APPEAL SUMMARY

Appeal ID: 27514	Project Address: 3231 SE 50th Ave
Hearing Date: 2/16/22	Appellant Name: Christopher Cardoza
Case No.: B-007	Appellant Phone: 503 9543065
Appeal Type: Building	Plans Examiner/Inspector: Chanel Horn
Project Type: commercial	Stories: 2 Occupancy: B Construction Type: V-B
Building/Business Name:	Fire Sprinklers: No
Appeal Involves: Alteration of an existing structure LUR or Permit Application No.: 21-115371-CO	
Plan Submitted Option: pdf [File 1]	Proposed use: Medical Clinic

Quest Center for Integrative Health
3231 SE 50th Ave., Portland, OR 97206
Project No. [21-019.1]

BEAM DETAIL

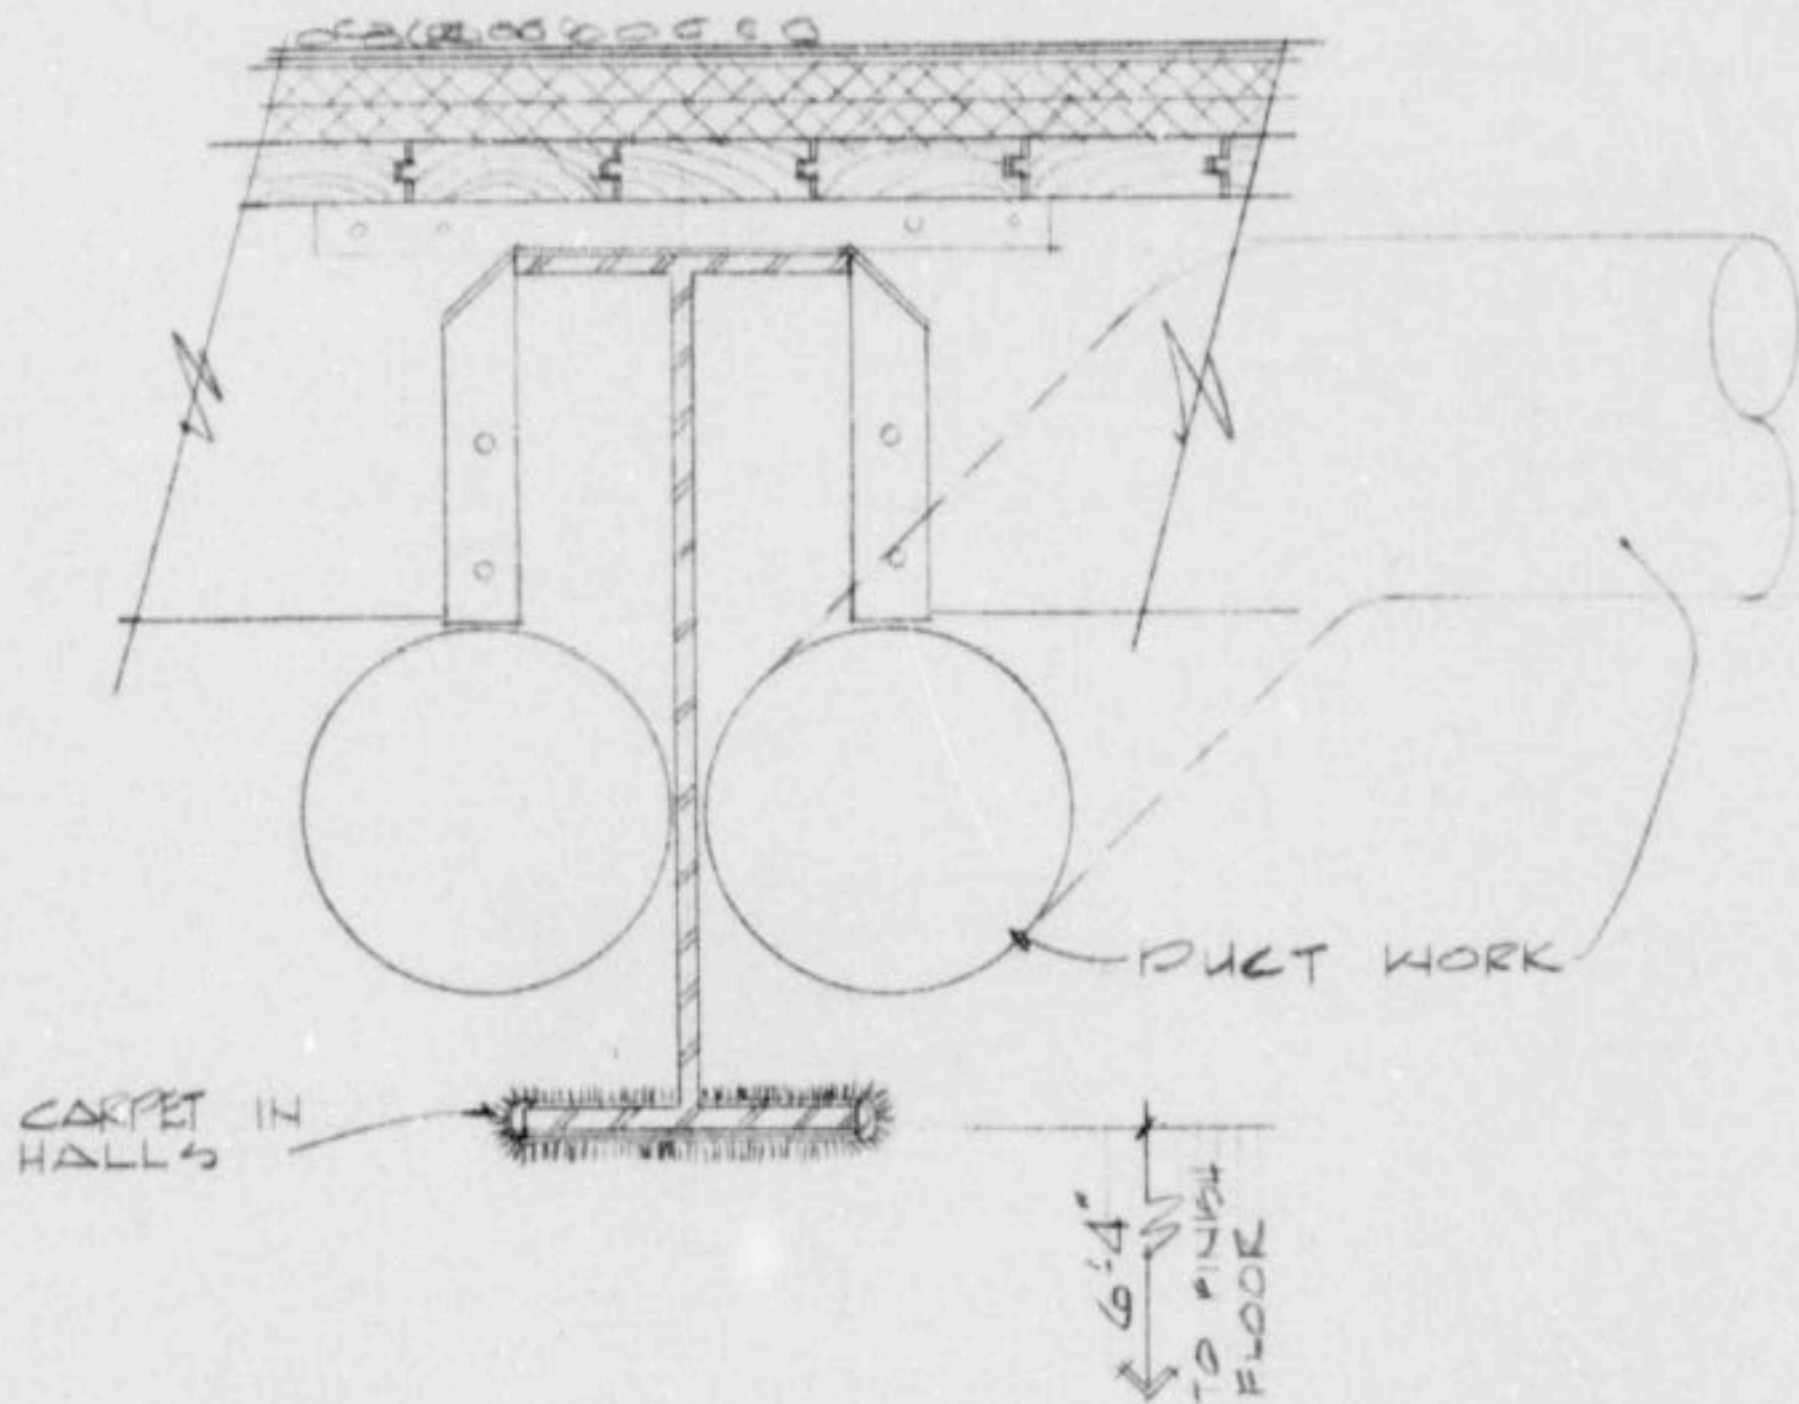
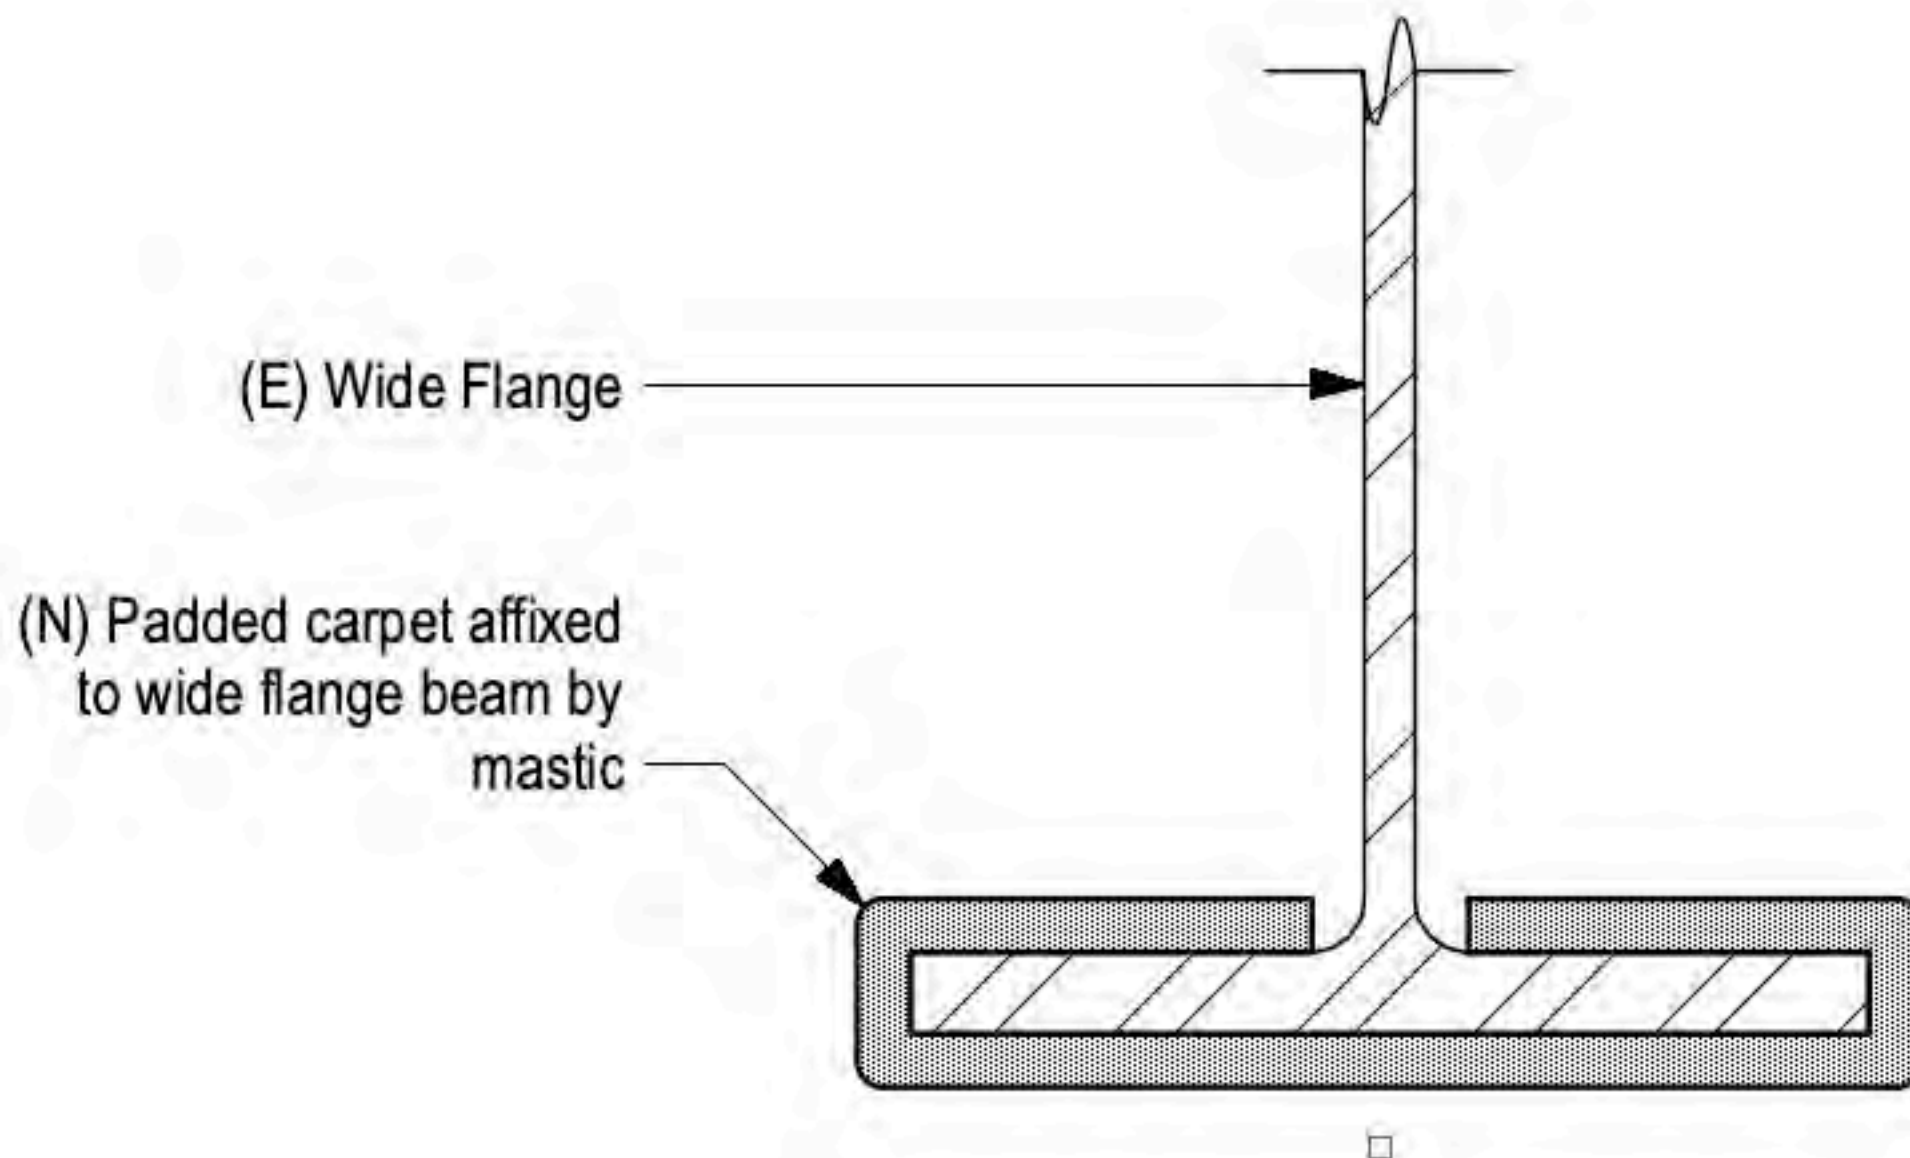
Existing steel beams project to within 6'-4" of the floor. Where this occurs within a corridor, the beams will be padded with carpeting.

- 1) Corridor doors and frames. 2) Exits from the 2nd floor and 4) Reception areas open to the corridor system: GRANTED with a smoke detection system installed in accordance with the Fire Marshal's recommendations.
- 3) Corridor ceiling height at beams: GRANTED as proposed.
- 5) Handicap restroom: GRANTED approving a single uni-sex toilet room on the 2nd floor provided it is in strict compliance with the code.
